Addendum No.: 2**Date Of Addendum: 4/15/2026**

**Underground Storage Tank Replacement at Harwinton Consolidated School
115 Litchfield Road, Harwinton, CT 06791
State Project 210-0037CVOT**

1 FIRST FLOOR NEW WORK PLAN
SCALE: 1/4" = 1'-0"

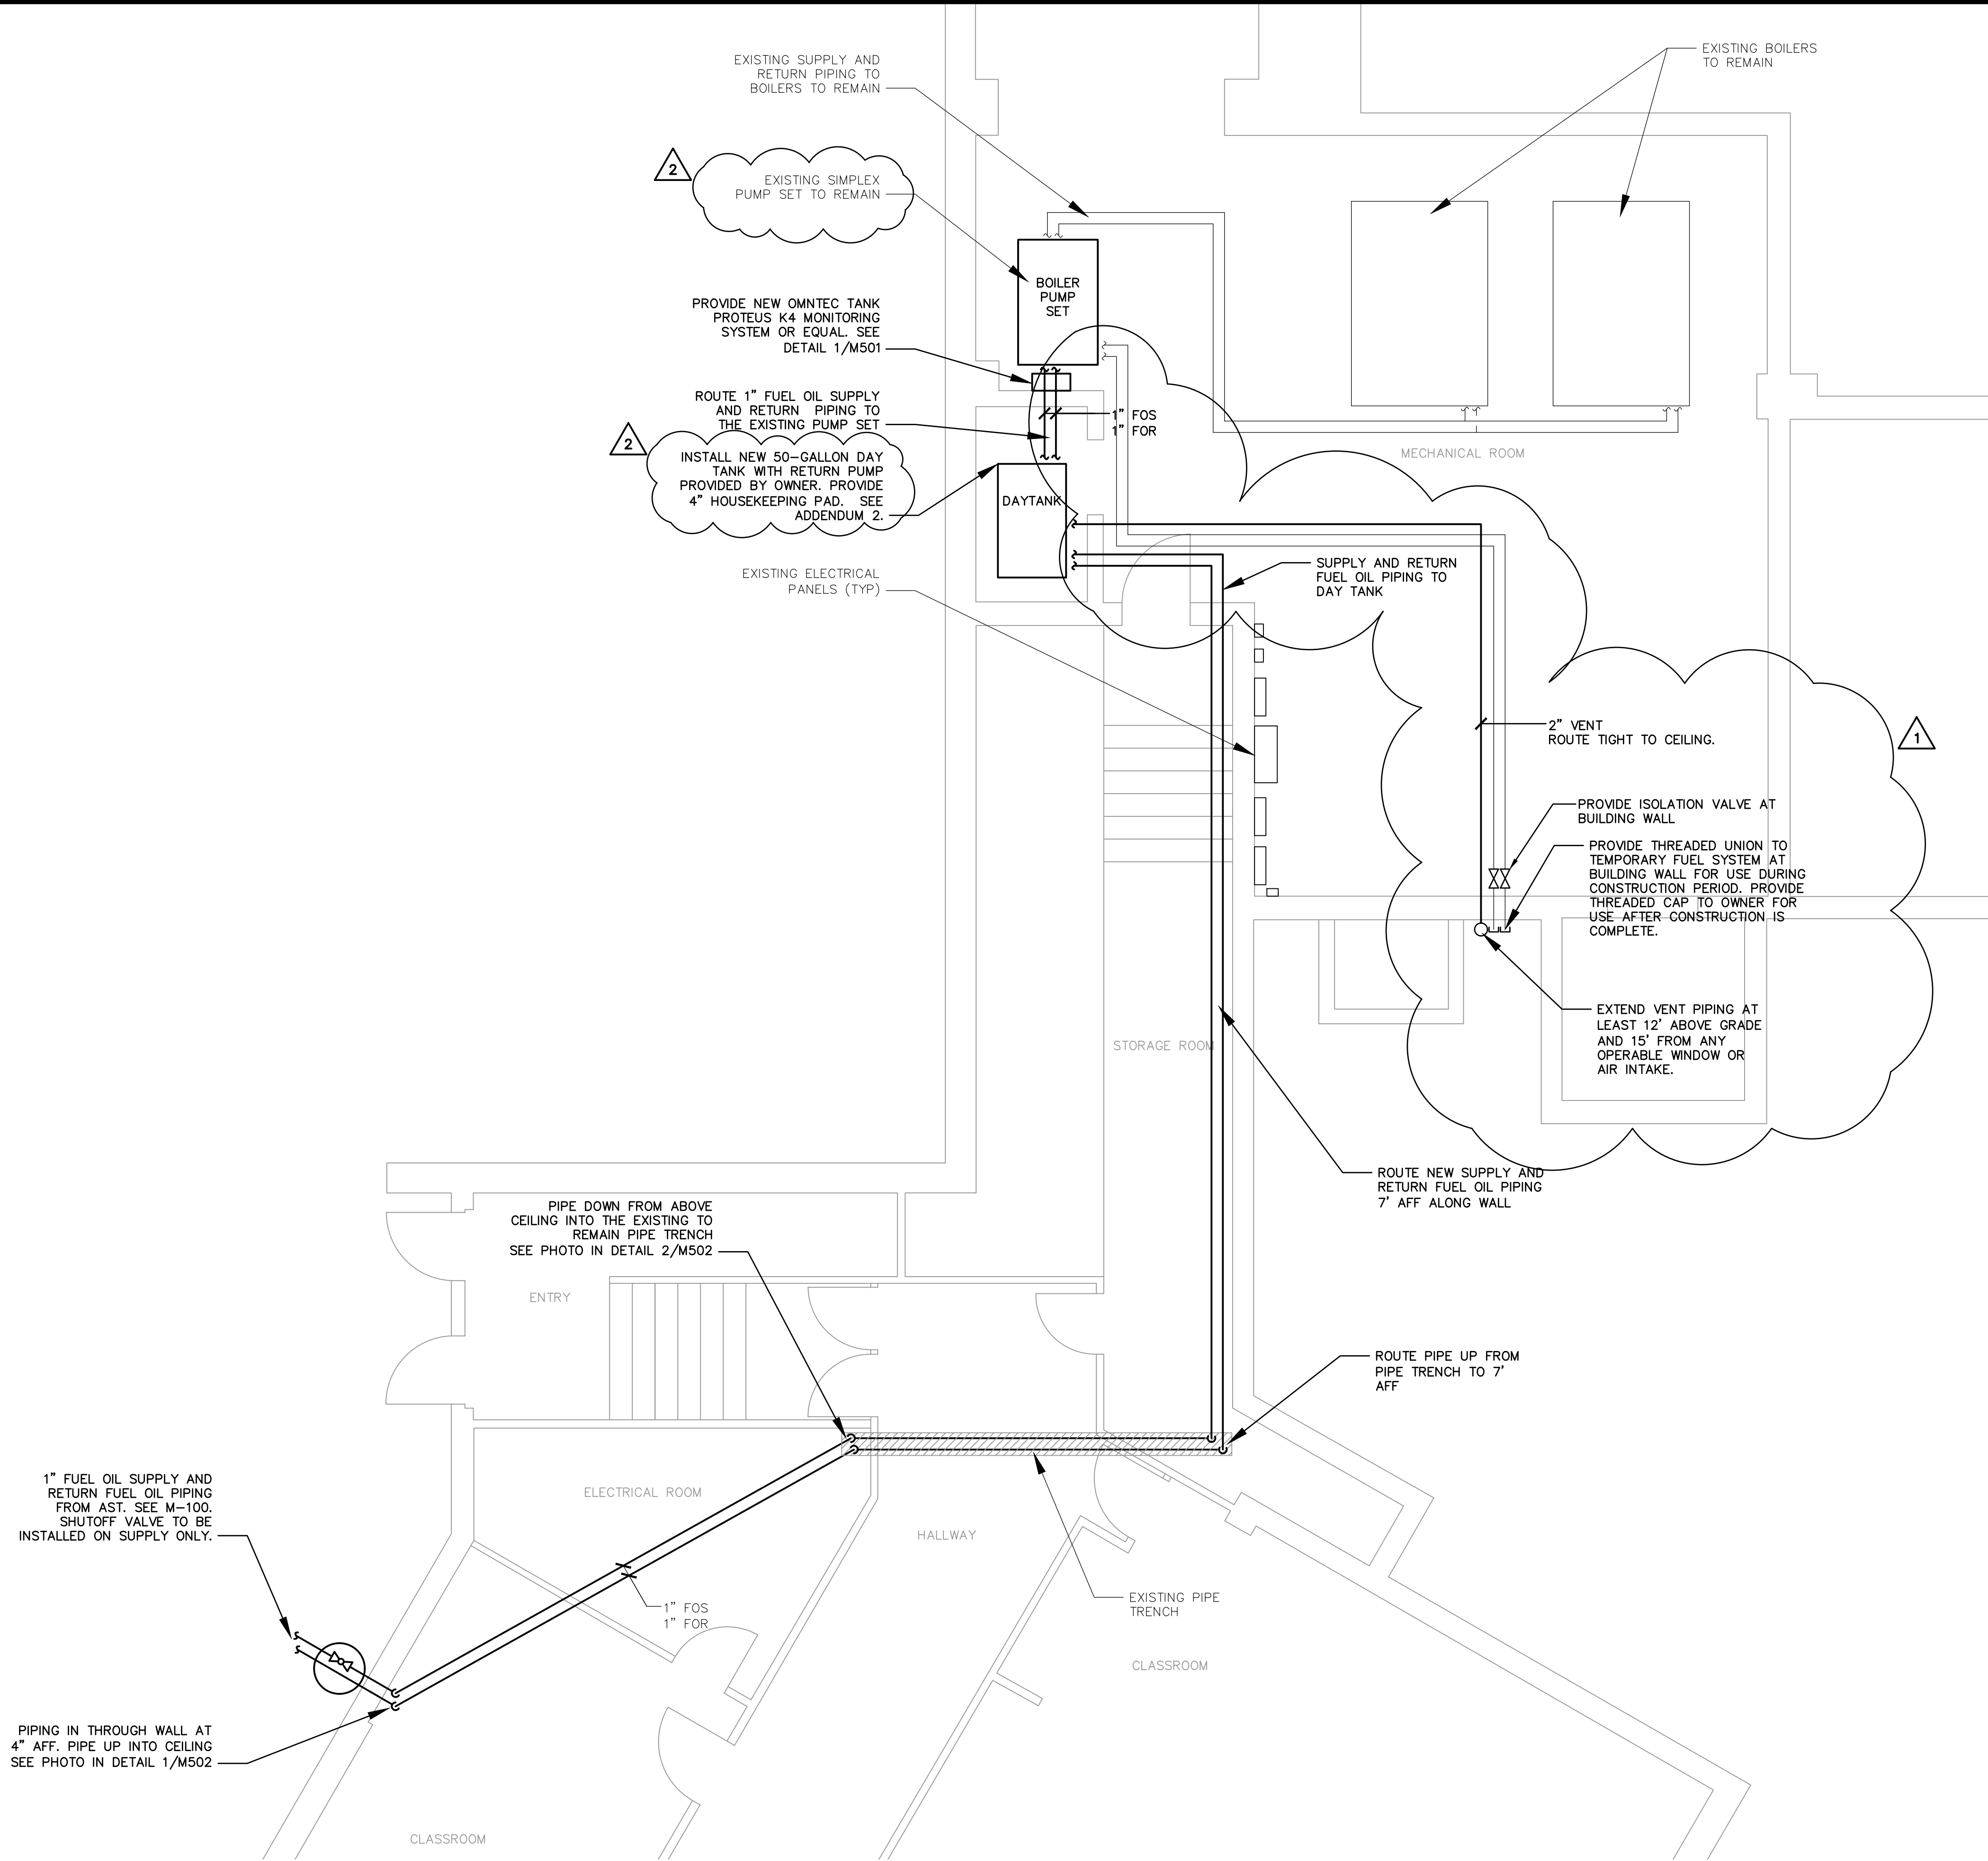
Scope Change: Due to extended lead times, RSD-10 intends to purchase the base-bid daytank and return pumpset from Pryco prior to issuing a contract with the selected contractor. Attached is the quote from Pryco indicating parts included with this equipment. Please removed this purchase from your scope.

See updated drawing M-101.
